ENGINEERING CHANGE NOTICE

DART AEROSPACE LTD

Date: 10.03.01	Job No.: RD0337MAR	ADR Yes/No: N	ADR Date:	ECN #: 10- 530
Product No.: D206-628		Created By: CP	Approved By:	
Item Name: Steps		Checked By:	General Manager Approval:

DART SERVICE INSTRUCTION

FIGURE 1
D206-628-013 (SHOWN) / -014 (OPPOSITE)
206 A/B FLOAT STEP INSTALLATION

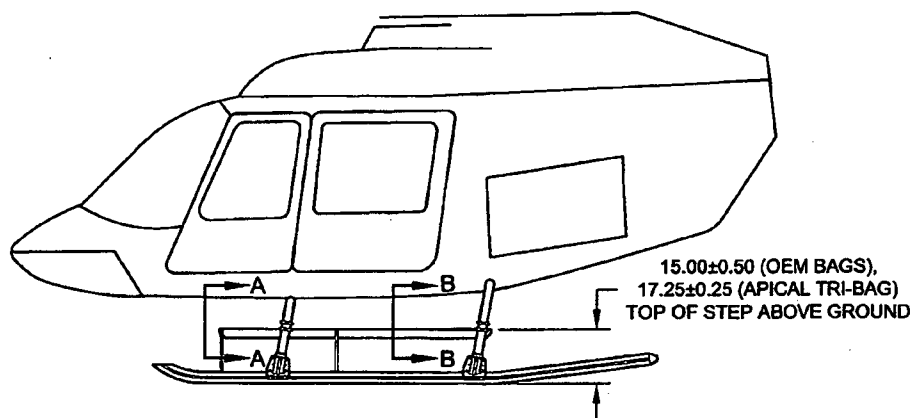
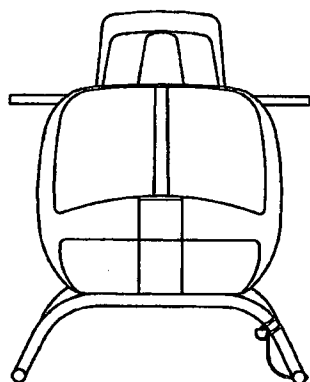
UNMODIFIED D206-628-013/-014 STEP INSTALLATIONS AT CHANGE 005 (OR EARLIER) WILL NOT INSTALL AT THE 18.50" HEIGHT REQUIRED FOR COMPATIBILITY WITH APICAL TRI-BAG FLOATS.

D206-628-013/-014 STEP INSTALLATIONS AT CHANGE 006 (OR LATER) CONTAIN NEW MOUNTING LUGS FOR COMPATIBILITY WITH APICAL FLOATS.

CONTRARY TO INSTALLATION INSTRUCTIONS IIN-D206-628, FOR COMPATIBILITY WITH APICAL TRI-BAG FLOATS, THE D206-628-013/-014 STEP INSTALLATIONS SHOULD BE INSTALLED AT A HEIGHT OF 17.25" PER FIGURE 1 OF THIS SERVICE INSTRUCTION.

WHEN INSTALLING THE MOUNTING LUGS, IT IS ACCEPTABLE TO USE LONGER/SHORTER AN4C BOLTS AS REQUIRED AND/OR INSTALL EXTRA AN960C416/416L WASHERS UNDER THE BOLT HEADS TO ENSURE 1.5 TO 4 THREADS IN SAFETY.

THE DSI-9500-011 LUG UPGRADE KIT IS AVAILABLE TO UPDATE EXISTING D206-628-013/-014 STEPS TO CHANGE 006. THE UPGRADE KIT INCLUDES ADDITIONAL LUGS FOR STEPS INSTALLED WITH APICAL TRI-BAG FLOATS (AT 17.25" HEIGHT). EXISTING D206-628-013/-014 STEPS INSTALLED WITH OEM FLOATS (AT 15.00" HEIGHT) DO NOT REQUIRE THE KIT. THE UPGRADE KIT SHOULD BE INSTALLED PER THIS SERVICE INSTRUCTION AND IIN-D206-628 REV. F.
